CARACOL CREEK SUBDIVISION UNIT 1

PRELIMINARY OVERALL AREA DEVELOPMENT PLAN APPLICATION (POADP)

Re: Caracol Creek POADP # 486 - B

P.O.A.D.P REVIEW

P.O.A.D.P.

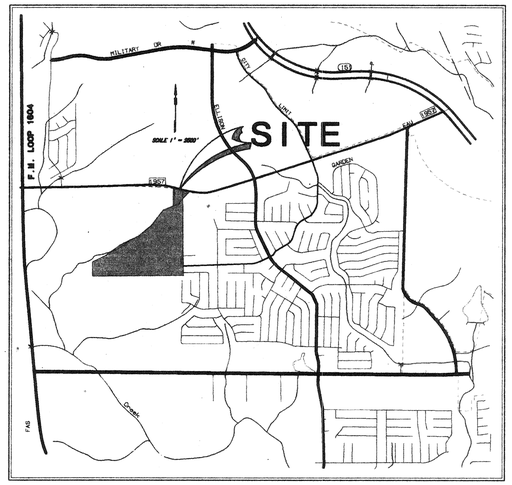
The City Staff Development Review Committee has reviewed Caracol Creek Subdivision Preliminary Overall Area Development Plan # 486 -B. Please find enclosed a signed copy for your files. Although your plan was accepted, please note the following:

- Based on the topography, a Flood Plain Study and drainage review will probably be required during the platting process.
- If the proposed development is not platted in phases or units this POADP will not be valid.
- Access and R.O.W. issues along State facilities need to be resolved with TXDOT. For additional information about these requirements you can contact TXDOT at 615-5814.

P.O.A.D.P. Reviewed for:	Comments
Noise Mitigation	For residential development directly adjacent to State ROW, the developer shall be responsible for adequate set-back and/or sound abatement.
R.O.W. Requirements	50' Flares required at the proposed intersection of FM 1957 and "Local Type B Street"
Access Limits/Restrictions	Maximum of 1 access point. Locations will be as directed by "Regulations For Access Driveways to State Highways".
WPAP Requirements	None

ADDITIONAL COMMENTS: At the time of platting, TxDOT will require a 1' non-access easement along the frontage of FM 1957. All access shall be from the future "Local Type B" street.

Comments: DRAINAGE EASEMENT WILL BE REQUIRED AND ADDRESS DURING THE PLATTING PROCESS

Comments: TIA needs to be submitted
1. before the approval of this POADP
2. Issue of Seascape needs to be resolved

1) THE ACREAGE REFLECTS THE FINAL BOUNDARY.
2) THE LOCATION OF THE LOCAL TYPE "B" REVISED.
3) THE ADJOINERS UPDATED.
4) UNIT PHASE LINES REVISED.

No.	Date	REVISIONS	App.
1	06/02/97	ADD STUB-OUT STREET - SOUTH PROPERTY	DAS

COPIES	DATE	NO.	DESCRIPTION
6		Ea	PDADP. *
			* We took Seascape off of location map.

COPIES	DATE	NO.	DESCRIPTION
3		Ea.	Revised PDADP - (added stub-out)
